| LEXINGTON-FAYETTE URBAN COUNTY GOVERNMENT CONTRACT CHANGE ORDER Page 1 of 2 | Date: | June 3, 2016 |
| | Project: | Idle Hour Park Improvements |

CHANGE ORDER NO. 3

SUBJECT: Request Council Authorization to Execute Change Order #3 with Bluegrass Contracting Corporation in an amount **Not To Exceed** \$81,678.00 for the Idle Hour Park Improvements Project, Contract #242-2015

Figure 7: Approximate Area of Observations

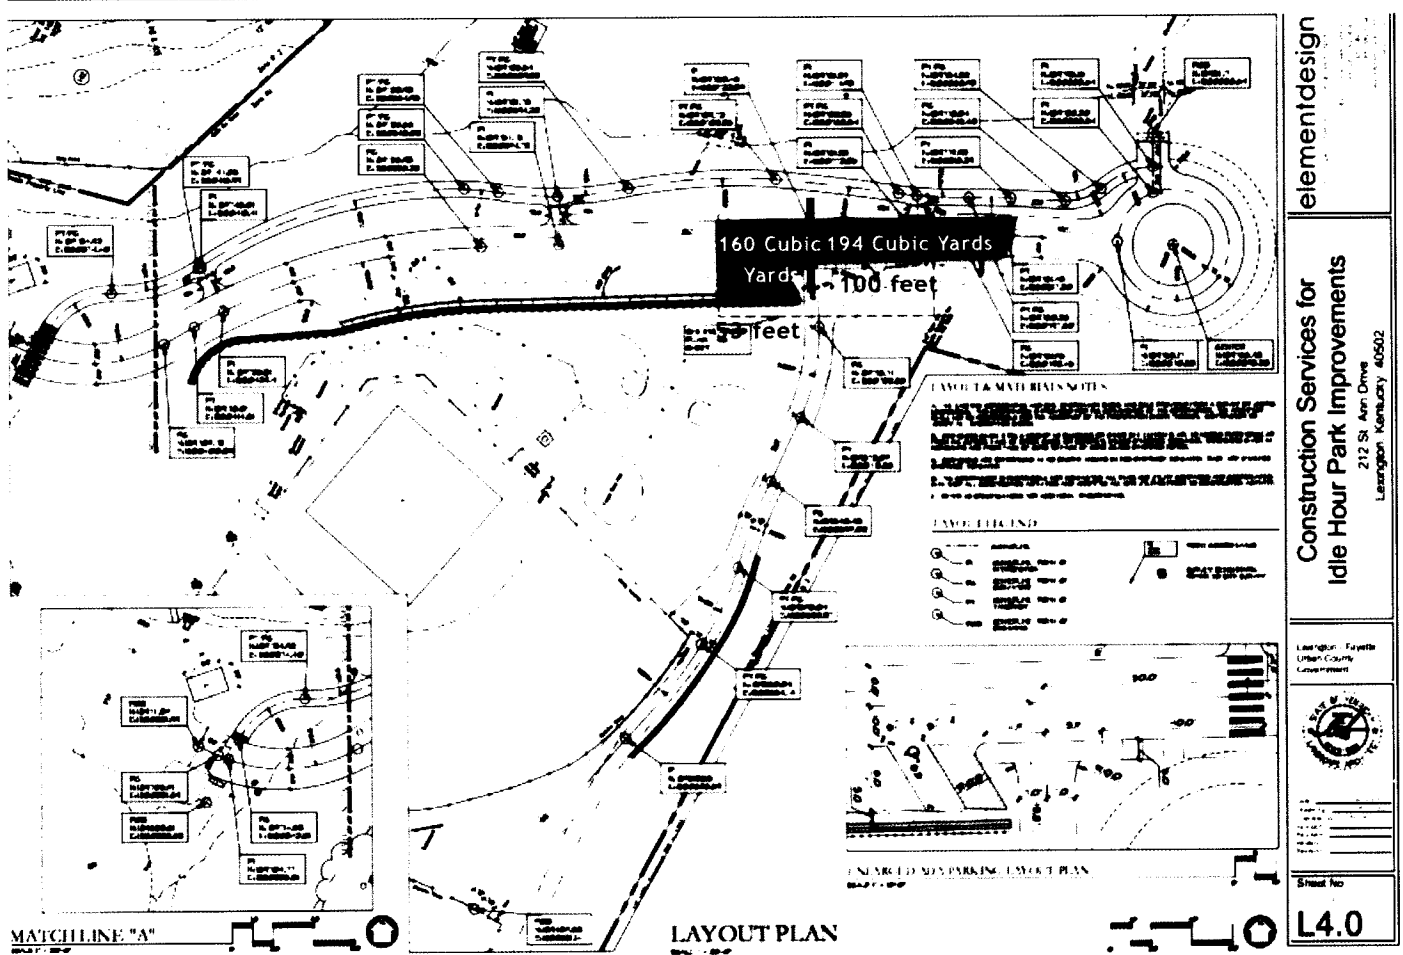
The proof roll revealed soft pumping material throughout the roadway. The pumping was evident throughout the full width of the proposed roadway. The soft pumping area measured to be 53 feet by 32 feet and 100 feet by 20 feet. We would recommend to extend the roadway undercut 5 feet beyond the roadway to maintain stability for a total of 363 cubic yards measured to be undercut and replaced.

Based on our reconnaissance of the site and our understanding of the project we believe the soft soils encountered will not support the proposed construction and will need to be stabilized to facilitate the construction above the subgrade. Such stabilization can be achieved by undercutting the soft materials down two feet, lining the soft area with a reinforced geotextile fabric and backfilling with a #2 stone like aggregate back up to the designed subgrade elevation. Once the stabilization has occurred the area should be evaluated by proof rolling to verify stability prior to placement of the pavement section.

Figure 1: Approximate Area of Observations

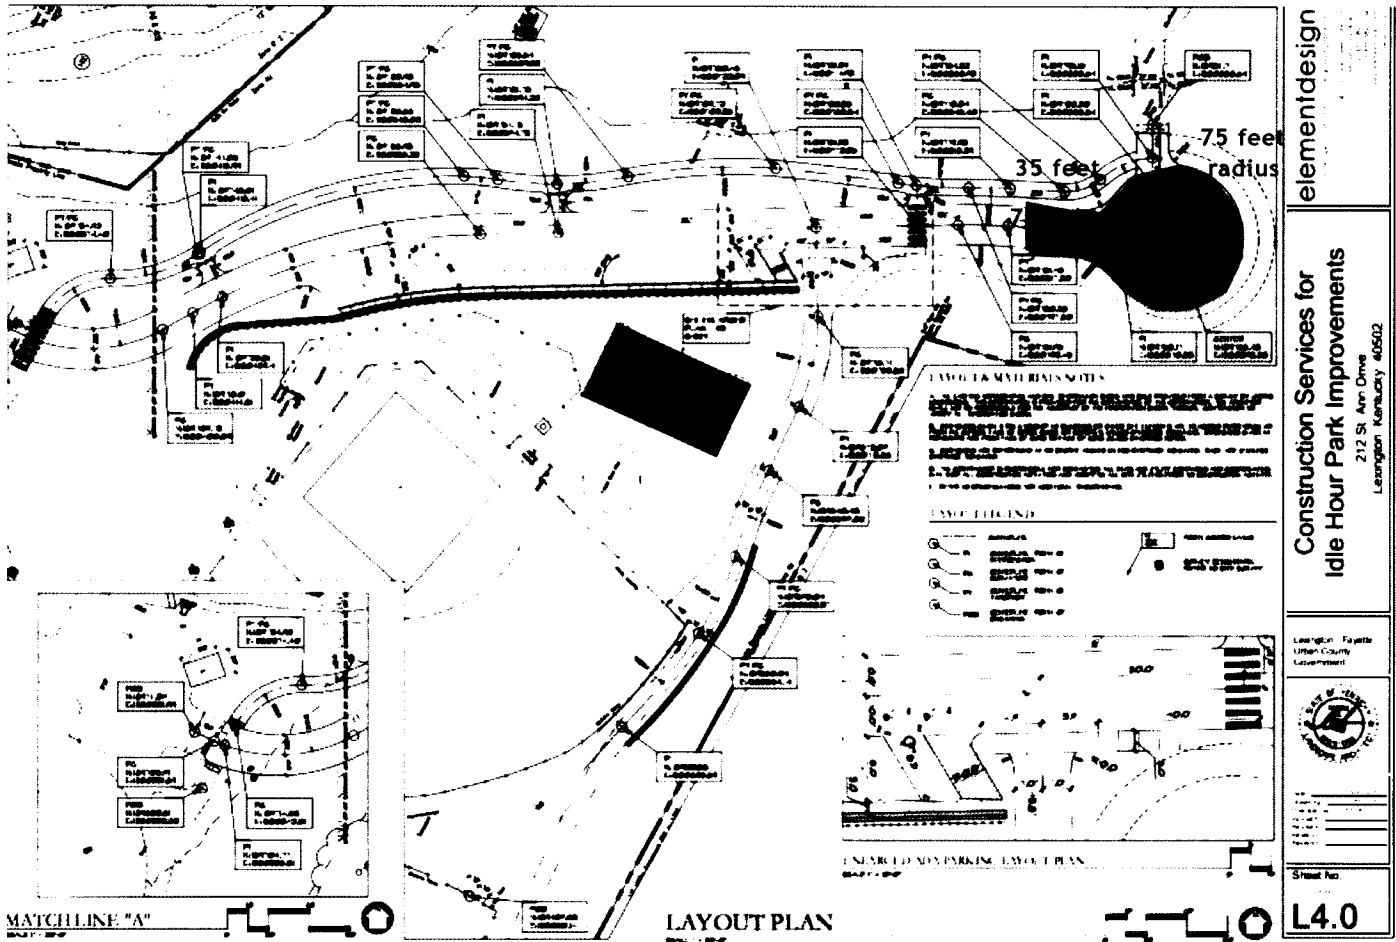
CSI observed a proof roll conducted by the contractor for the soil sub-grade approximately 35 feet of the roadway and the cul-de-sac utilizing a loaded tri-axle dump truck. The proof-roll consisted of the loaded truck routing over the sub-grade in a forward and backward motion, then moving laterally one tire width and repeating the motion until the exposed sub-grade had been rolled. The proof roll revealed soft pumping material throughout the roadway and the cul-de-sac. The pumping was evident throughout the full width of the proposed roadway. The soft pumping area measured to be 35 feet by 20 feet for the roadway and 75 feet radius of the cul-de-sac. We would recommend to extend the roadway undercut 5 feet beyond the roadway to maintain stability for a total of 450 cubic yards measured to be undercut and replaced.

Based on our reconnaissance of the site and our understanding of the project we believe the soft soils encountered will not support the proposed construction and will need to be stabilized to facilitate the construction above the subgrade. Such stabilization can be achieved by undercutting the soft materials down two feet, lining the soft area with a reinforced geotextile fabric and backfilling with a #2 stone like aggregate back up to the designed subgrade elevation. Once the stabilization has occurred the area should be evaluated by proof rolling to verify stability prior to placement of the pavement section.

Bluegrass Contracting cut the proposed basketball court to sub grade elevation. After the area had been cut, it was observed and appeared to have mixture of some clay and topsoil at this elevation.
